MAVERIK, INC. STORE #250

5100 EAST & 2500 NORTH EDEN, UTAH

LANDSCAPE PLAN

**1 SITE PHOTOMETRIC PLAN**  
E-1.2 SCALE: 1"=20'-0"

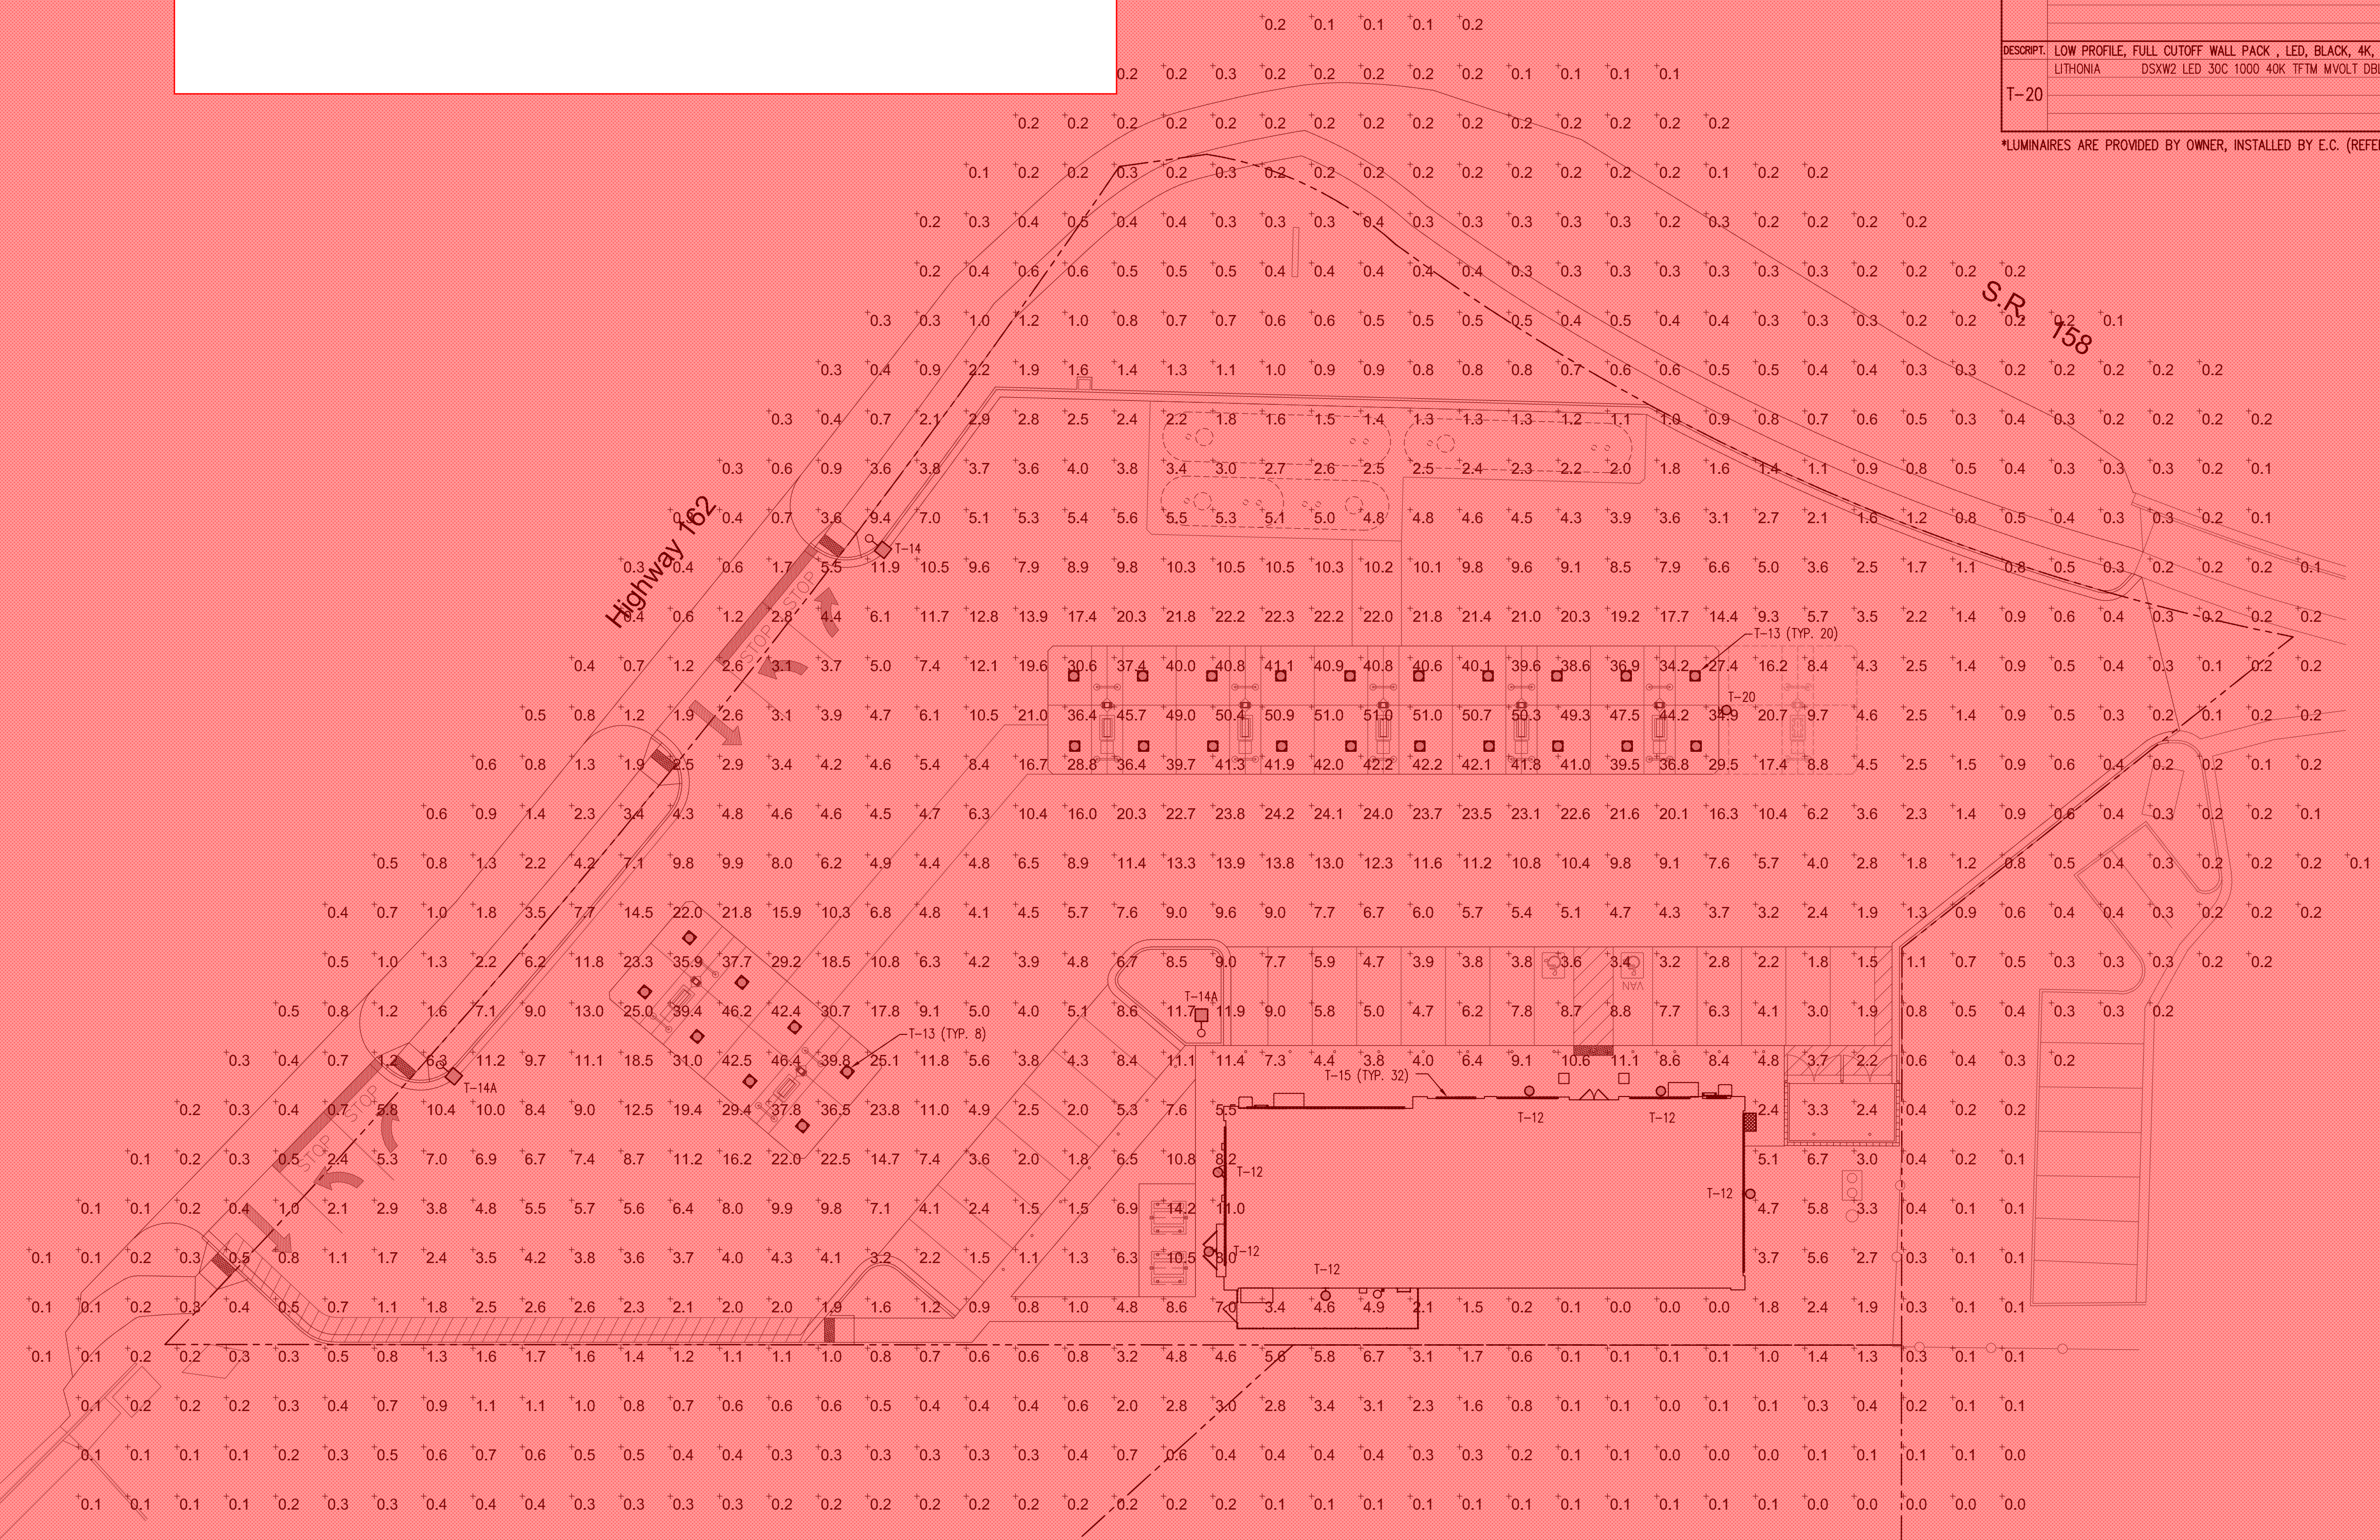
The lighting plan for this project, including the photometric schematic is not in compliance with the Ogden Valley Outdoor Lighting chapter on many levels. The Ordinance is attached to this review. Please read it and propose a new lighting plan that is in compliance.

2  
PR1.0 FRONT ELEVATION  
1/4" = 1'-0"

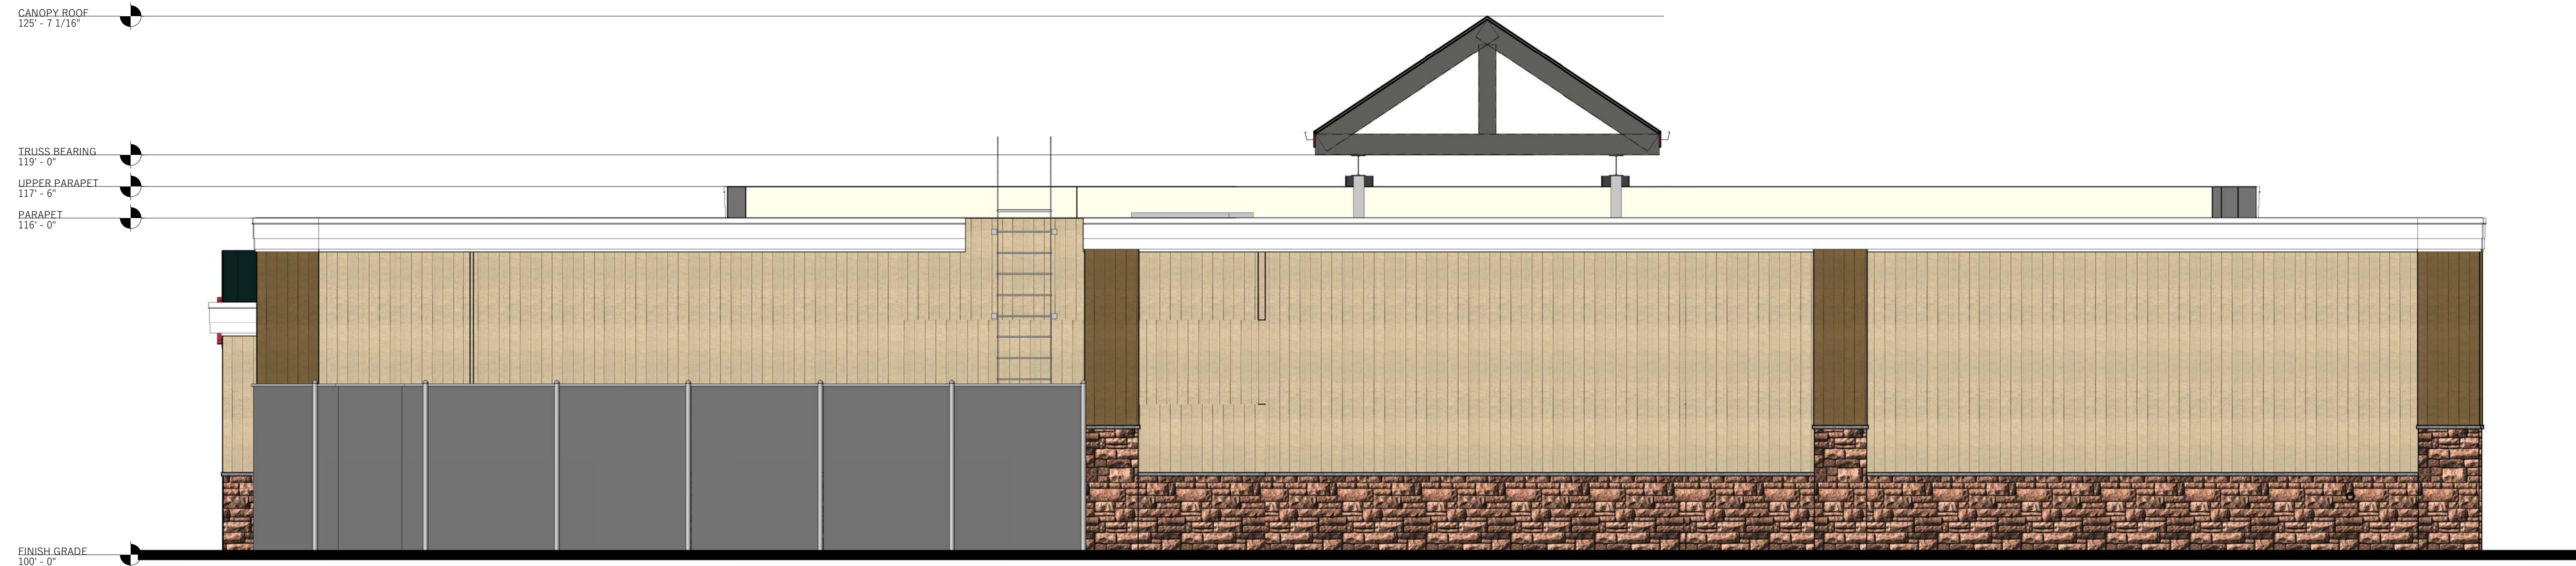
Please include a list of materials will the make up the outside of the building (Brick, metal siding?)

**5 Trash Enclosure Plan**  
SCALE: NONE

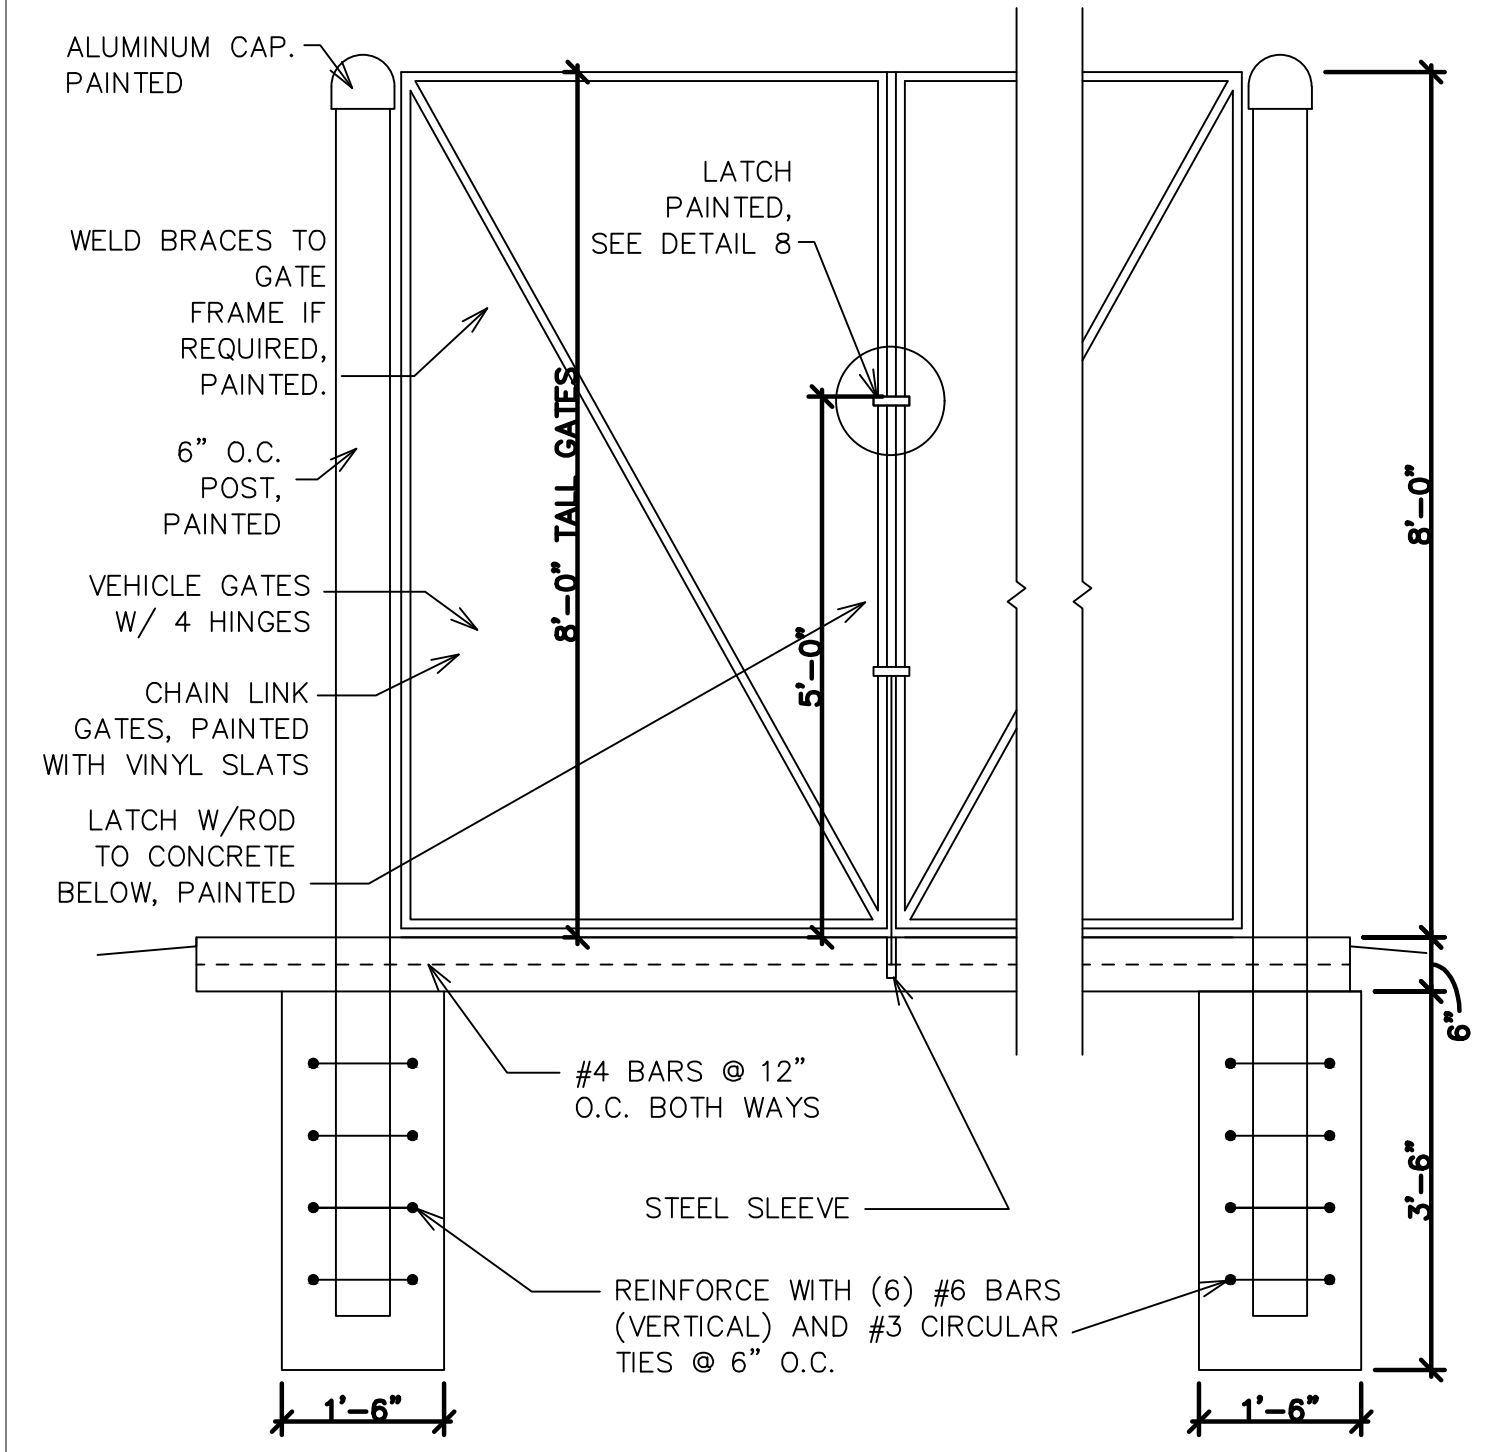
Trash dumpsters. (1) Trash dumpsters shall be located in an area shown on the approved site plan. Specific approval of this item is required. (2) All trash dumpsters shall be screened from street or public view by a six foot screening device on three sides. The fourth side shall be a gate constructed of opaque materials. (3) The screening device for a metal dumpster shall be placed adjacent to or on a concrete pad six inches in thickness. The concrete pad shall match the adjacent grade and paving and provide for positive drainage.
